Our Ref: DJL: L.T2522.003

RE: PEER REVIEW OF FLOOD RISK ASSESSMENT FOR HVO CONTINUATION PROJECT

Torrent Consulting was engaged by NSW Department of Planning and Environment (DPE) to undertake a peer review of the of the of the Hunter River Flood Assessment for the Hunter Valley Operations Continuation Project (SSD 11826681 and SSD 11826621) (the Project).

Change in Model Topography

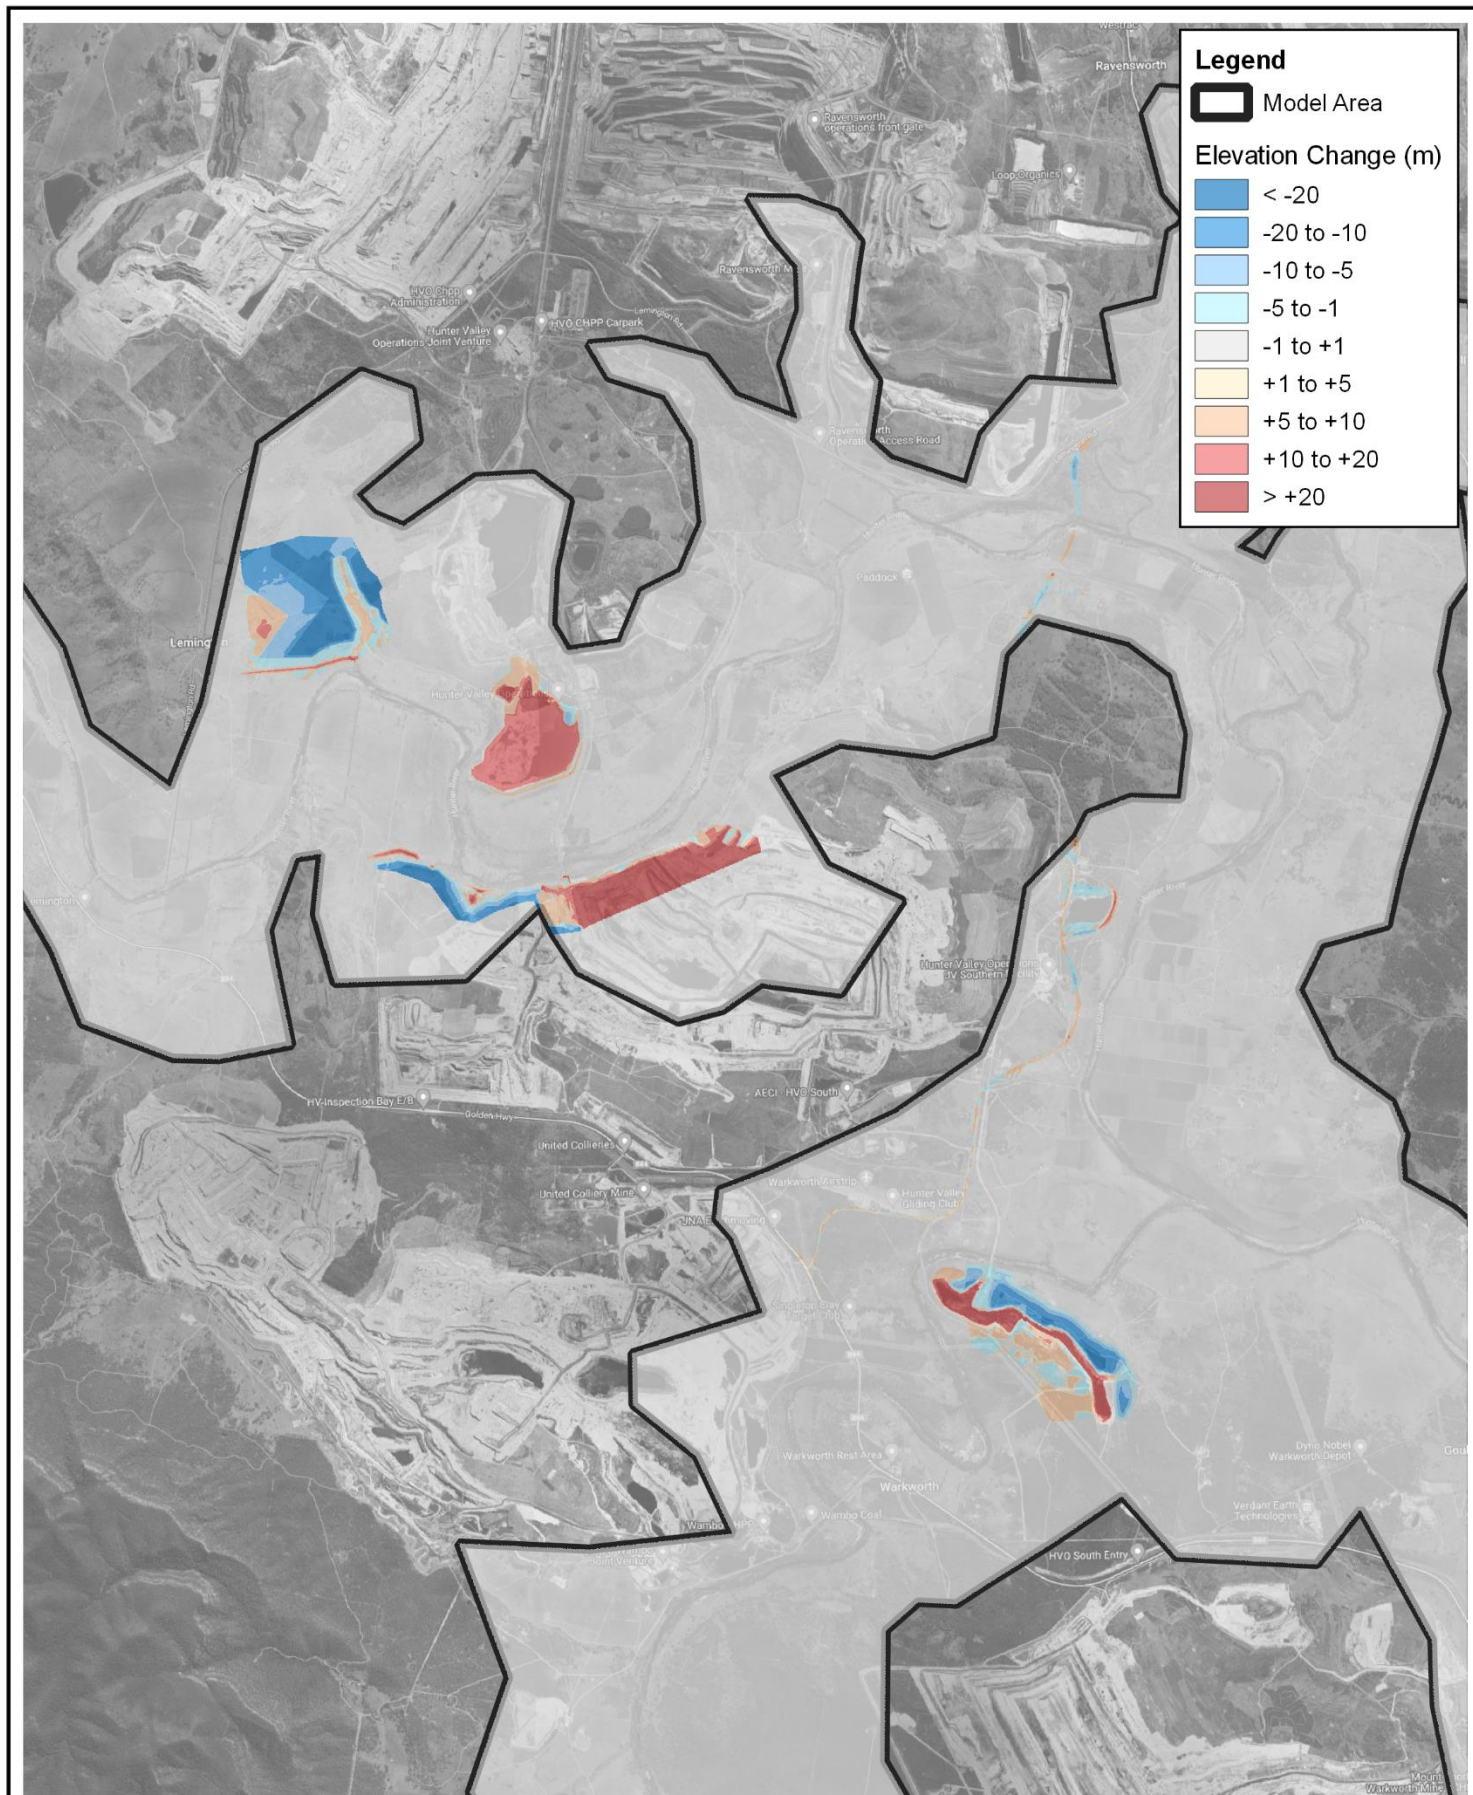
Figure 1 presents the difference in model topography from existing to design conditions. The DEM modifications appear to appropriately represent the scale and nature of the proposed works. However, it is noted that the adopted model grid resolution of 8m may not explicitly define the contiguous crest levels of narrow linear features such as levees and road embankment where they are read into the model directly via a DEM surface (1 or 2m resolution) and have not been reinforced by other 2d_shape layers.

- A number of the topographical modifications for the proposed works are defined by direct import of design DEMs of 1 and 2m grid resolution. The underlying TUFLOW model resolution of 8m may not provide for adequate representation of the design in the modelled topography. It is recommended these be reviewed to consider impacts on design flood behaviour and potential localised impacts. It is noted any refinement in this regard is not expected to fundamentally change the flood assessment, but confirm local conditions.
